Project: **Design/Engineering Services –
BPCPC Mechanical System
Upgrade**

RE: **Addenda #1**
of Pages: **26**

OLA has been retained by the Battery Park City Authority (BPCA) to perform this evaluation of the HVAC systems and geothermal well system that serve the building located at 75 Battery Place. The building is a 42,000 square foot facility built in 2009-10 for the Battery Park City Parks Conservancy's (BPCPC) headquarters.

Photo 3. Well water sample

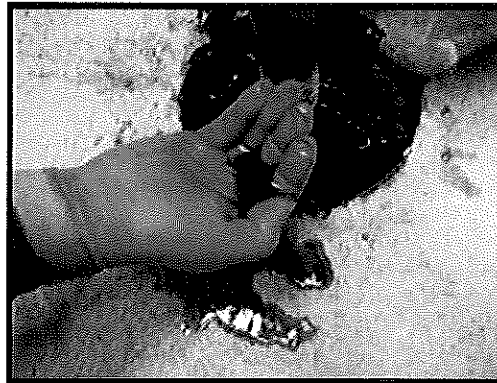
The water that first flowed from the sample spigot was black, with a slight brackish odor (Photo 3). The water contained fine black sediment and was tepid to the touch. The discharging water did not clear after approximately 10 minutes of pumping. After an hour of circulated water a sample was collected that was clear with minor rusty orange suspended particles and had no odor.

We can conclude from the well completion reports and the analytical results that the SCW portion of the geothermal HVAC system is not capable of providing sufficient heat exchange with the earth to support the 90 tons of peak load demand. The two SCWs combined are more likely capable of providing heat exchange to support approximately 30 tons of peak load demand. The groundwater quality results indicate, based on the Ryznar Stability Index of 8.4, that the water is aggressive or capable of heavy corrosion.

Photo 4. HX-1 disassembled

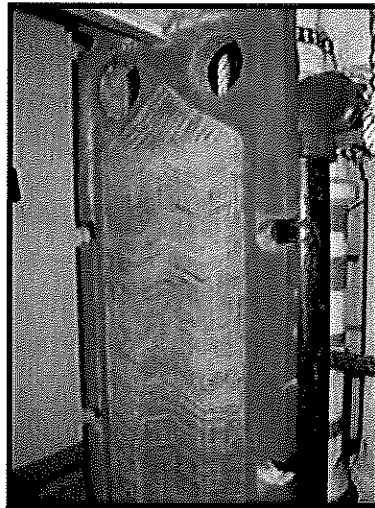
Heat exchanger HX-1 was originally intended to provide free cooling to the AHU-1 free cooling coil and the radiant floors for free cooling. Per our discussions with the operators, the radiant floor free cooling system never operated satisfactory in that condensate formed on the floors making the system unusable. In addition, the heat exchanger plates were severely corroded by contact with the well water and eventually failed (Photo 4). At the time of our site visits, HX-1 had already been disassembled and taken out of service.

- Reactivation and retro-commissioning of the well pumps. Possible replacement if existing pumps are not serviceable.
- New Titanium Plate/Frame HX-1 (30 tons)
- New well-water filtration system to provide longevity of HX-1 life.
- New 3-way valve to allow bypass of HX-1 during winter time.
- New controls and BMS programming to support free cooling operation.
- Reactivation/Retro-commissioning of AHU-1, 30 ton free-cooling coil.
- Replace corroded well water piping in mechanical rooms with plastic or corrosion proof pipe (PE or PVC) wherever possible.

Photo 6. Imploded outside air intake duct to AHU-4

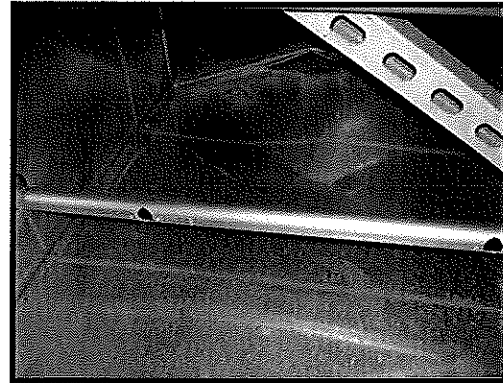
that when AHU-1 is active, the other air handling units all exhibit backwards airflow through the fresh air intake ducts. This results in loss of ventilation to the rest of the building. It was also noted that the outside air intake duct to AHU-4 was imploded and in need of repair. (Photo 6)

- Provide new required fresh air intake (FAI) ductwork to the AHUs, modify and/or increase the FAI, return and mixed air duct connections to the AHUs and the existing mixed air plenums.
- Provide adequate cross bracing for the existing FAI ductwork per SMACNA requirements. Replace sections of imploded fresh air intake duct where necessary.
- Consider in-line return air fans and ductwork in order to improve return air (RA) flow to AHUs 2 - 5. The 4th Floor office unit appears to be in need of a return fan and the others should be reviewed.
- Provide testing and balancing for AHUs, including balancing to meet the economizer conditions.
- Revise control systems and sequence of operations to interlock new FAI and return air fans with AHU-1 and other AHUs.

Photo 7. Fresh air fan (FAI-1)

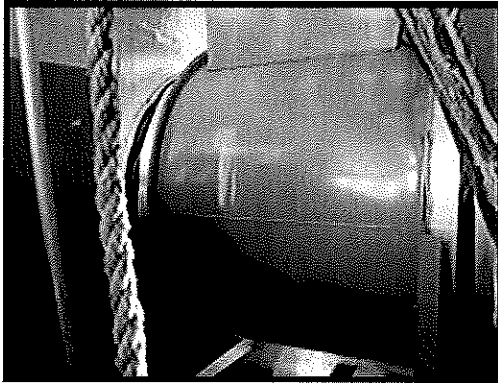
At the time of our site visits, the fresh air fan (FAI-1) had been taken out of service, the ductwork disconnected, and the air intake duct was left open to the 11th floor roof mechanical shed area. (Photos 7 & 8) It was not clear why the original FAI fan was taken out of service. It is possible that it was taken out of service due to the generator exhaust being recirculated in the fan, but this could not be confirmed (refer to Section 2.5).

- Remove the existing FAI-1 fan and related ductwork at the 11th Floor roof. Patch and seal the existing duct riser. This duct riser shall be used exclusively for smoke purge in the future.

Photo 9. Generator Exhaust

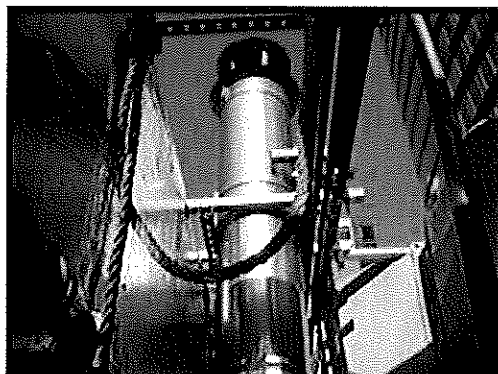
The existing supply fan FAI-1 was taken out of service and the ductwork disconnected, which has created an additional problem related to the generator exhaust. The symptoms stated by the building operators are that when the emergency generator is operating, the odors are drawn into the common fresh air intake duct and these odors disperse throughout the building. This is not surprising since the discharge of the generator exhaust is in very close proximity to the fresh air intake (less than 15'-0" apart). It should also be noted that the fresh air intake duct termination is also in close proximity to other building exhausts which discharge inside the 11th floor mechanical shed area (Photo 9).

Our recommendations outlined under Section 4.3.1 above will also correct the deficiency with generator exhaust recirculation, by moving the fresh air intake to the Battery Place side of the building

Photo 10. Exhaust fan EF-3

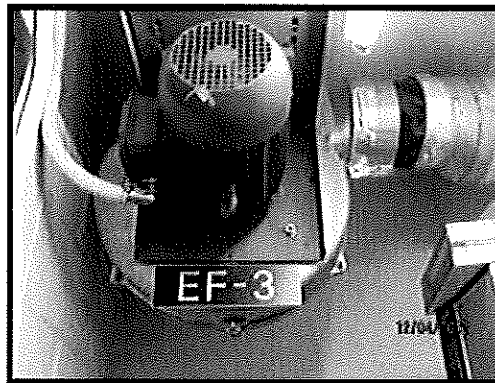
It was noted by the operators that the existing vehicle capture exhaust system is not working properly. From our inspection of the design drawings, it appears that the location of the exhaust fan EF-3 is not correct and must be relocated downstream of all the hose reels in order for the system to work correctly. In addition, it was noted that the existing hose reels do not have end-caps to close off hoses that are not currently being used (Photo 10).

- Remove the existing EF-3 fan from its present location on the 1st Floor and install a new exhaust fan with additional capacity on the 3rd Floor. Reconnect new high volume/static exhaust fan to the main 14x10 exhaust duct riser.
- Modify controls, and reconnect electric power to the fan.
- Rebalance air system to determine if all vehicle maintenance air outlets are exhausting the scheduled CFM.
- Provide removable end caps on all existing vehicle hose ends, removing them only when respective system is in use.

Photo 11. Fan coil unit FCU-2

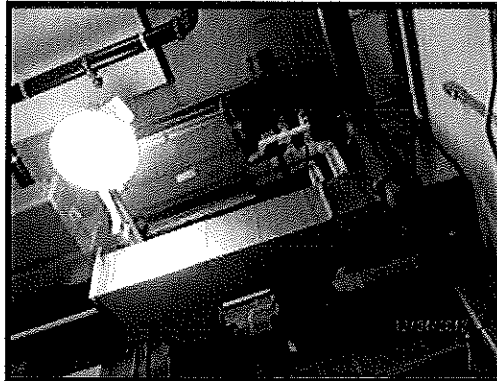
Presently, the air conditioning for the main lobby produces temperatures that are too hot in the summer, and too cold in the winter, indicating that cooling and heating capacities may be inadequate. Air conditioning is provided from fan coil unit FCU-2 (Photo 11). Ventilation air is provided from AHU-1 that is designed to supply air at 68°F, essentially compromising the lower temperature supplied from FCU-2. Heating is provided from a wall cabinet unit heater CUH-A (17 MBH). It was also observed that the horizontal fan coil unit FCU-2 is located in the garage maintenance area, thus pulling garage air into the Lobby.

- Disconnect and remove existing fan coil unit FCU-2 from the present location. Install a new fan coil unit with additional heating and cooling capacity. Disconnect the existing supply air duct from the 16x6 main supply from AHU-1, and cap the end.
- Remove the existing return air linear diffuser and ductwork. Patch ceiling.
- Install a new 3"Wx48"L linear in the side wall above the existing supply air ductwork and linear. Connect the new return air ductwork directly to the back of the new FCU-2; also connect an 8x6 section of ductwork with motorized damper from AHU-1 into the back of the new FCU-2 to provide outside air in order to meet the NYC building code requirements for ventilation.
- The existing cabinet unit heater CUH-A can remain; however, increase fan speed and air capacity if possible. Modify system control sequences.
